UNITED STATES
DEPARTMENT OF THE INTERIOR
BUREAU OF LAND MANAGEMENT

APPLICATION FOR PERMIT TO DRILL OR REENTER RECEIVED

2. Name of Operator DEVON ENERGY PRODUCTION COMPANY LP		8. Lease Name and Well No. ALEUTIAN 10-3 FED COM 214H
3a. Address 333 West Sheridan Avenue Oklahoma City OK 73102		9. API Well No. 6137 30-015-45570
3b. Phone No. (include area code) (800)583-3866		10. Field and Pool, or Exploratory FIELD AND POOL / BONE SPRING

APPROVED WITH CONDITIONS
Approval Date: 12/07/2018

Figure 1. Cross-sections and plans for typical road sections representative of BLM resource or FS local and higher-class roads.

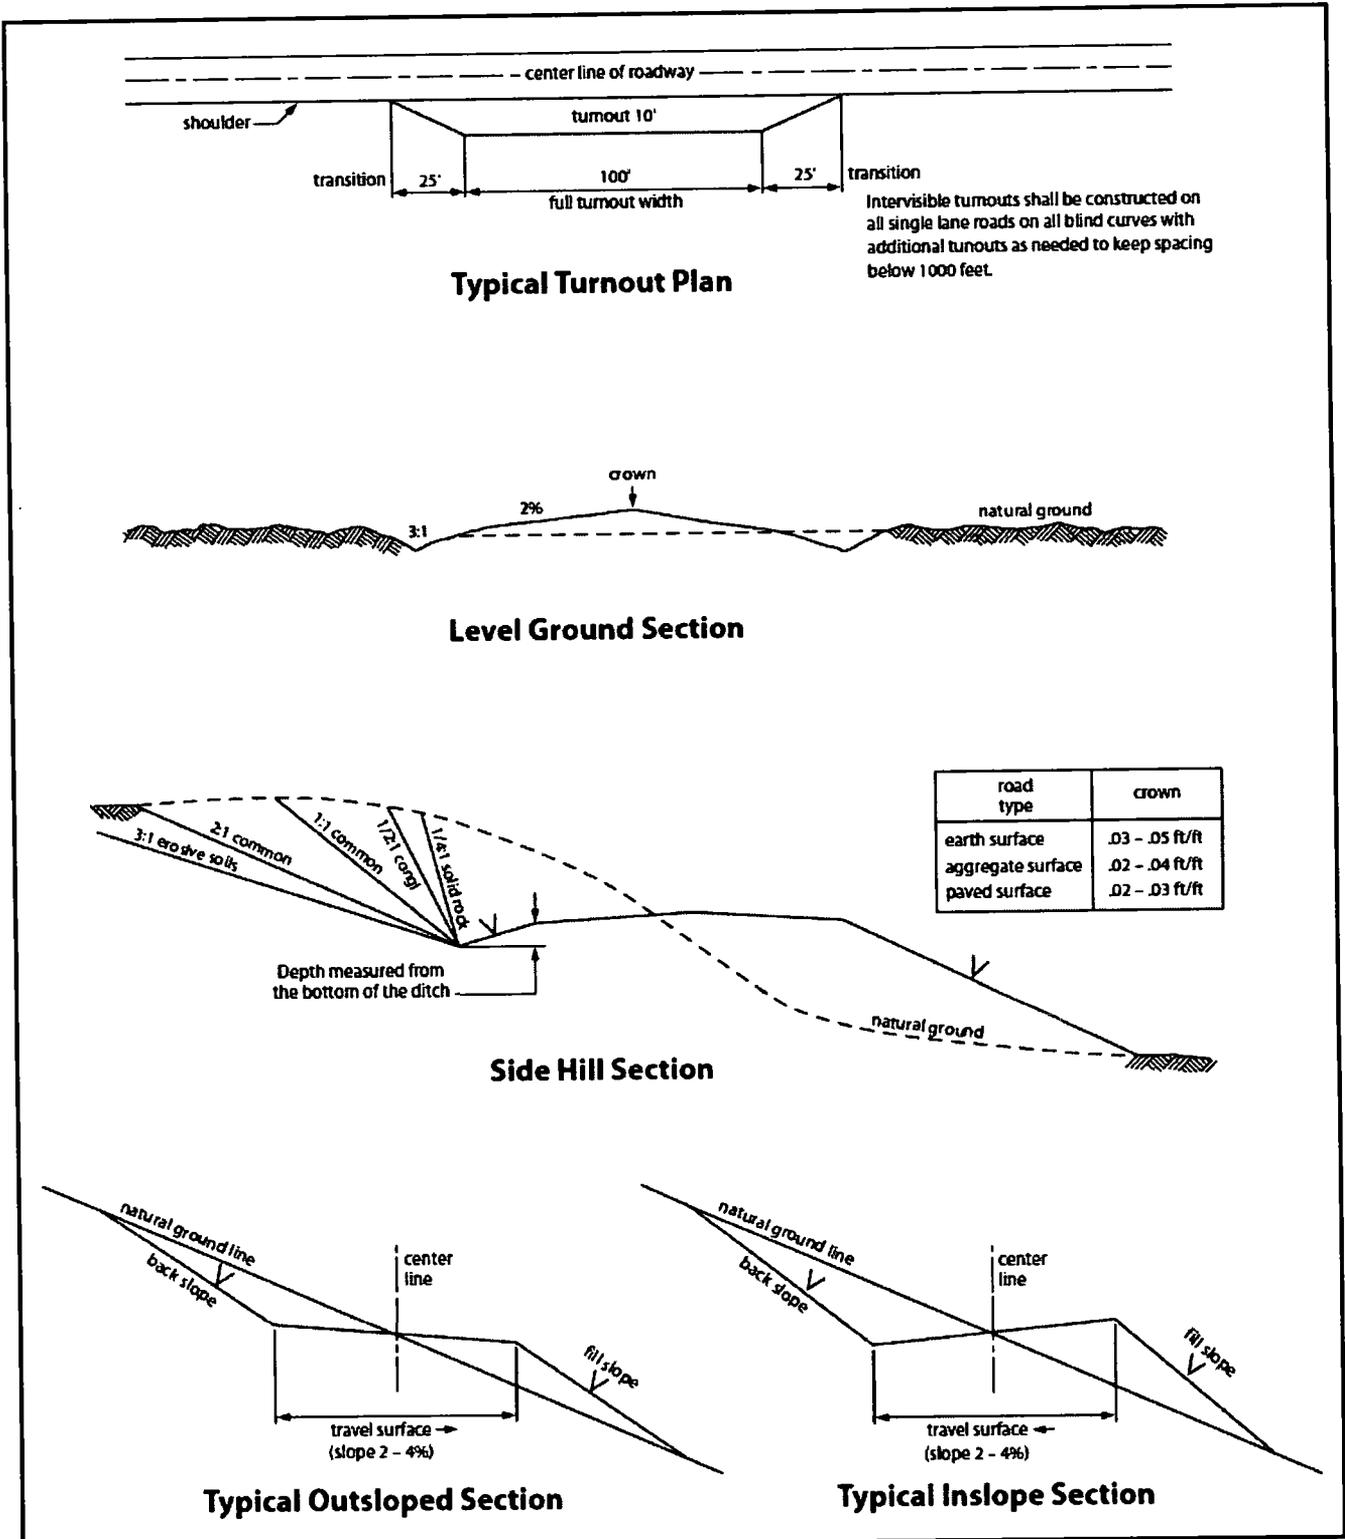
Crowning shall be done on the access road driving surface. The road crown shall have a grade of approximately 2% (i.e., a 1" crown on a 14' wide road). The road shall conform to Figure 1; cross section and plans for typical road construction.

Vehicle turnouts shall be constructed on the road. Turnouts shall be intervisible with interval spacing distance less than 1000 feet. Turnouts shall conform to Figure 1; cross section and plans for typical road construction.
